COMMUNITY DEVELOPMENT COMMISSION
Village of Bensenville
VILLAGE HALL
June 2, 2020 6:30 PM

1. Consideration of Variations Pertaining to the Construction of a Car Wash at 904-910 W. Irving Park Road

CDC Case #2020 – 07

**Gem Car Wash, LLC
904-910 W. Irving Park Road**

SITE PLAN
1"=25'-0"

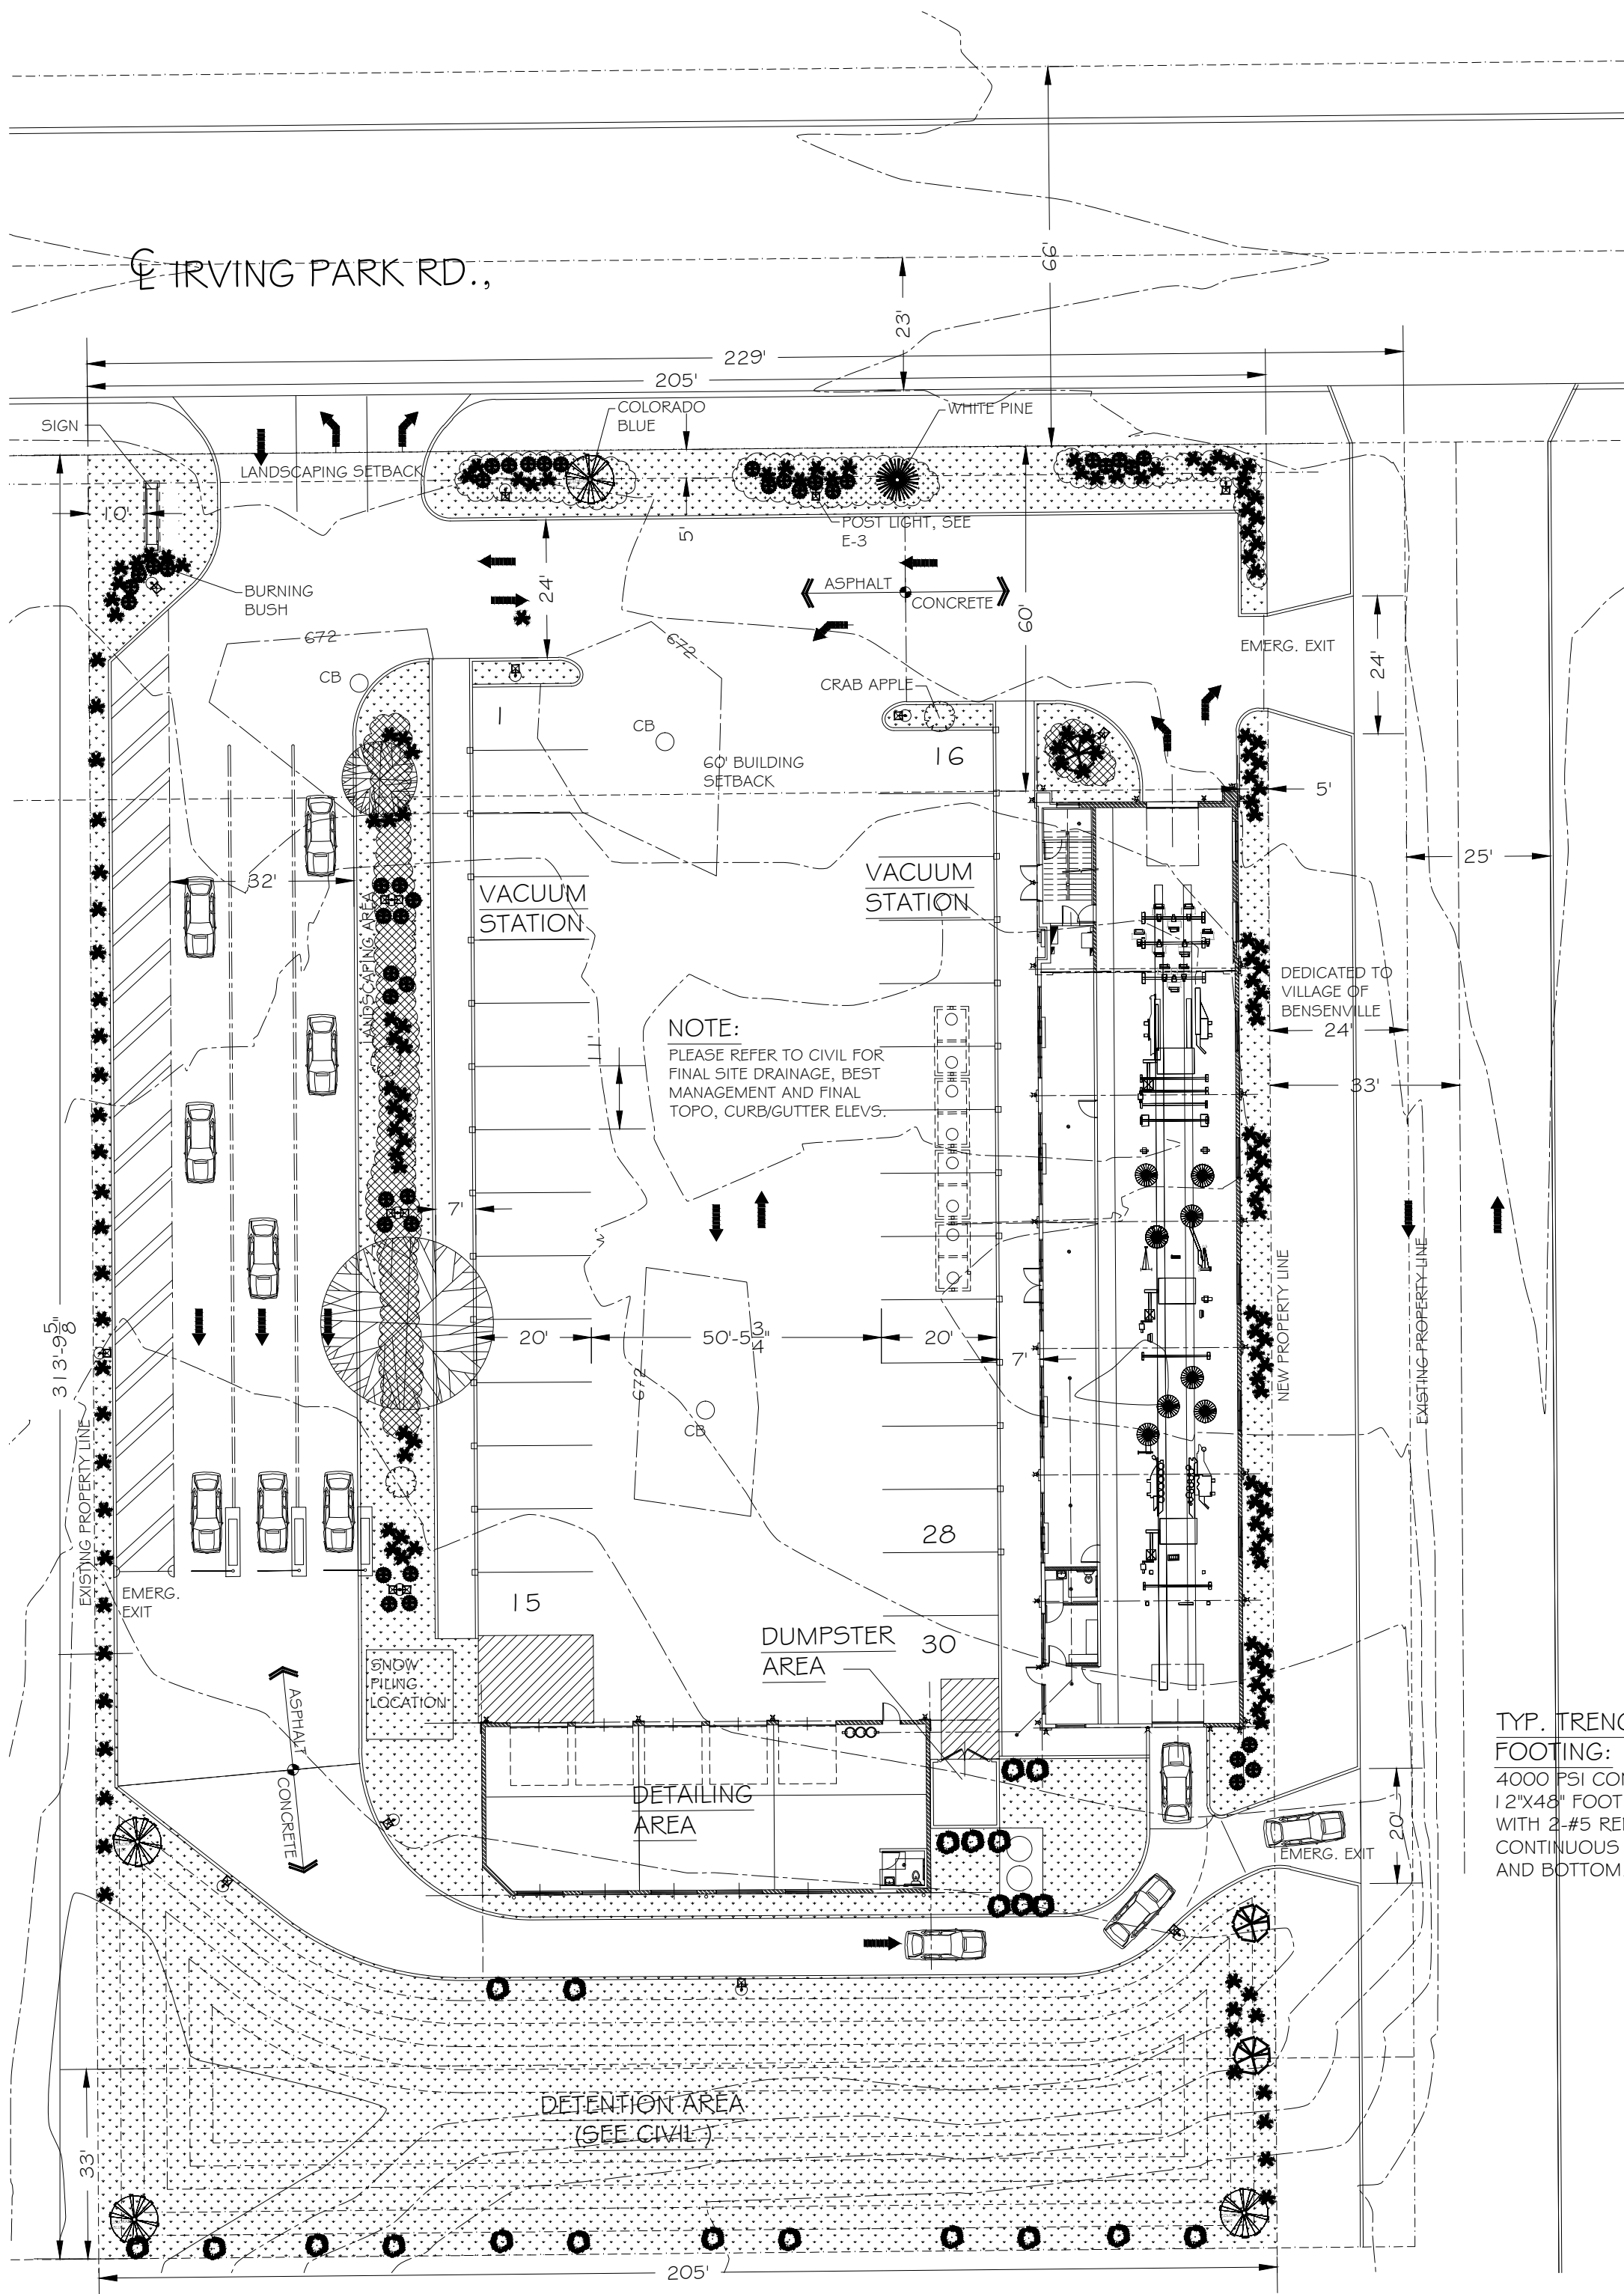
- 5) A Per Section 10 – 8 – 8 – 1 of the Village Zoning Ordinance, the maximum widths for a one-way driveway and a two-way driveway are 12 feet and 26 feet, respectively. Plans indicate a two-way driveway of 35 feet off Irving Park Road and two one-way driveways, 15 feet and 11.5 feet, off Eastview Avenue.

- a. Plans indicate a two-way driveway of 35 feet off Irving Park Road and two one-way driveways, 15 feet and 11.5 feet, off of Eastview Avenue. The driveway on Irving Park Road and the north driveway on Eastview Avenue exceed those requirements.

- 7) Per Section 10 – 8 – 9 – D of the Village Zoning Ordinance, drive-through lanes shall include a bailout lane, which shall run parallel to the drive-through and provide unobstructed exit capability to all vehicles.

- 9) Per Section 10 – 9 – 5 – A of the Village Zoning Ordinance, shade canopy shall be required for a minimum of 40% of parking area hardscape.
 - a. Proposed landscape plans do not meet this requirement. Staff calculates that approximately 14,000 SF of the parking area hardscape shall be covered by shade canopy. Staff recommends the Petitioner submit a new landscape plan with more shade trees throughout the parking area, as there looks to be room on the island that separates the drive-through lanes from the vacuum station area.

- 10) Per Section 10 – 9 – 5 – C of the Village Zoning Ordinance, one landscape island shall be provided for every 10 contiguous parking spaces.
 - a. Proposed plans indicate only 2 landscape islands. Staff recognizes that the Petitioner does not wish to impede patron access to vacuum stations.

- a. Photometric plan indicates outdoor lighting will exceed one foot-candle on the north, east, and west lot lines.
 - b. Staff has concerns regarding potential light pollution adversely impacting the surrounding residential properties.
